NAVIGATION AND VESSEL INSPECTION CIRCULAR NO. 3-75

*Subj: Bulk Grain Cargoes

RESOLUTION A.264(VIII)

AMENDMENT TO CHAPTER VI OF THE INTERNATIONAL CONVENTION FOR THE SAFETY OF LIFE AT SEA, 1960

Figure 1

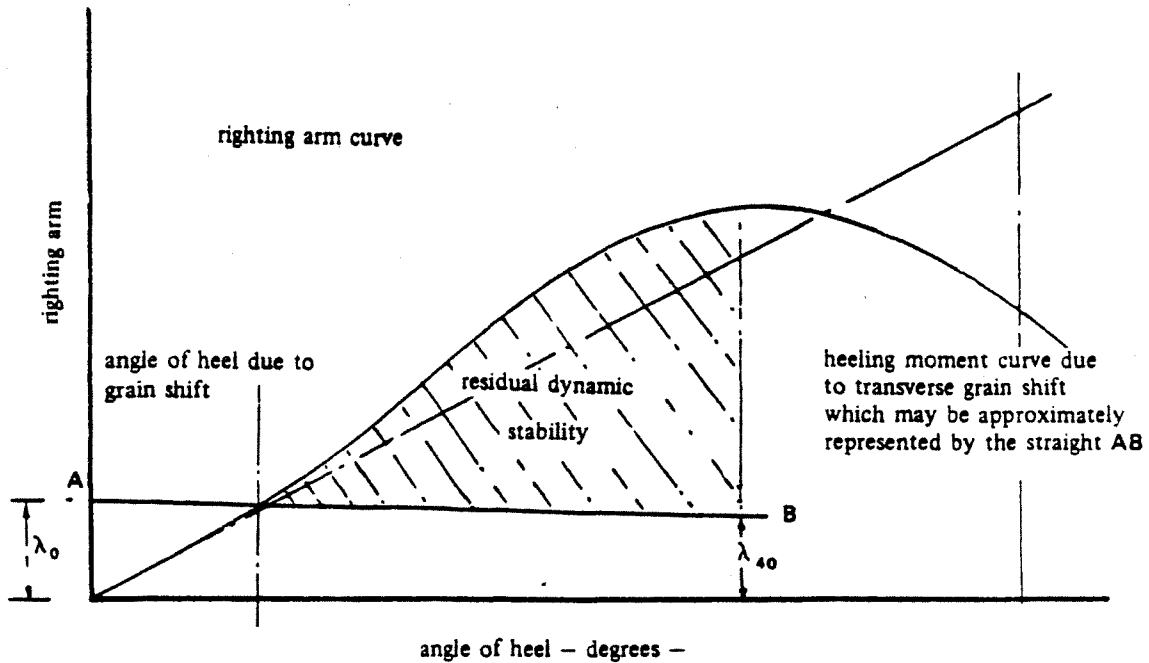
Replace "(a)" and "(b)" by "(1)" and "(2)".

Figure 2

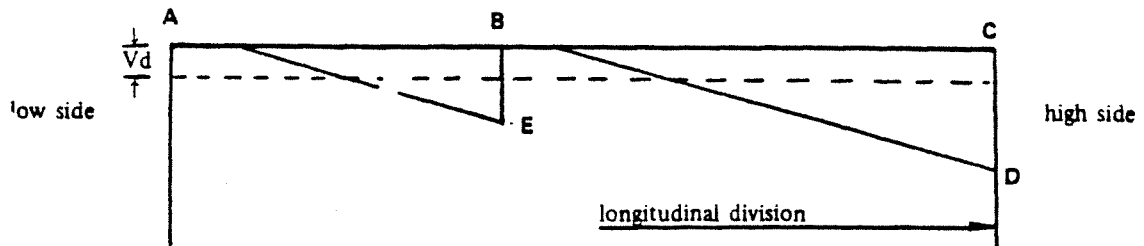
Page 9 – Notes on Figure 2

Figure 3

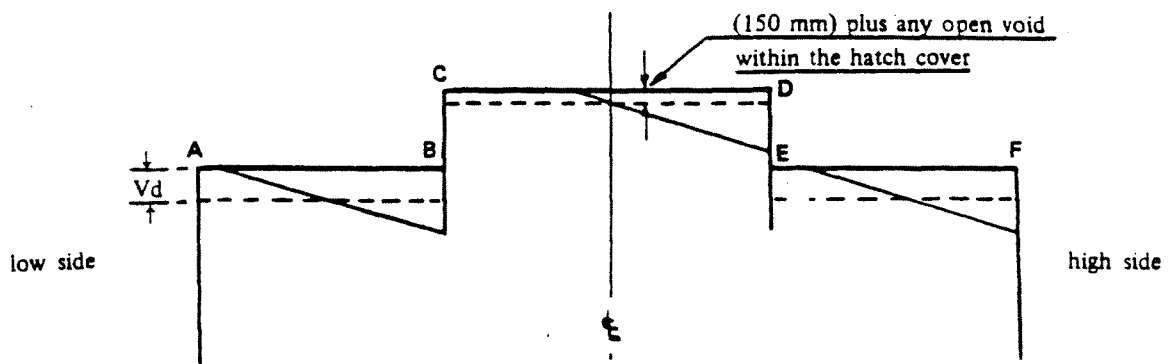
Delete () around 150 mm.
